## IMPORTANT SAFETY RECALL NOTICE

This notice applies to your vehicle. Model: Grand Vitara VIN: 01234567890123456

Suzuki Motor Corporation has decided that a defect in the Supplemental Restraint System (SRS) which relates to motor vehicle safety exists in certain 2006~2011 Suzuki Grand Vitara and 2007~2011 Suzuki SX4 vehicles.

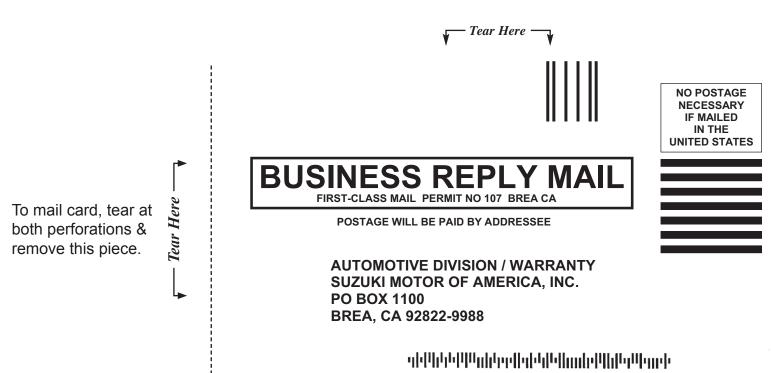
Affected vehicles may develop an electrical circuit disconnection within the front passenger sensing system sensor mat that is built into the front passenger seat bottom cushion. The disconnection is due to repeated flexing of the sensor mat from use of the front passenger seat. If this condition occurs, the "AIR BAG" light in the instrument cluster and, the front passenger's seat belt reminder light will come on. Also, the "PASS AIR BAG OFF" indicator light will remain off because the front passenger air bag will remain enabled. In a frontal impact of significant magnitude, the front air bag will deploy with full force - even with a child, or small adult, in the front seat. Air bag deployment with a child or small adult in the front passenger seat increases the risk of severe injury or death to that occupant. Do not install a child or infant restraint system in the front passenger seat until your vehicle is repaired - Suzuki recommends that whenever possible children should be seated in the rear seat. Likewise, do not have a small person, such as a child who has outgrown child restraints, or a very small adult, sit in the front passenger seat. Consult your Vehicle Owners Manual for seating information. Lastly, please always be sure that all occupants wear their seat belts. Your safety, and your passenger's safety, is paramount to Suzuki Motor Corporation.

Recall replacement parts are now available to correct this condition. Your authorized Suzuki Service Provider will replace the front passenger seat bottom cushion in your vehicle with one that includes an improved sensor mat. This repair will be performed at no cost to you for parts and labor. Please contact your authorized Suzuki Service Provider to schedule an appointment to have your passenger seat bottom cushion replaced. Please call as soon as you receive this important Safety Recall Notification letter and, mention Recall Identification Code "VD". In addition, to provide the fastest service your vehicles repair part is identified at the top of this correspondence, your Suzuki Service Provider may ask you for this part number.
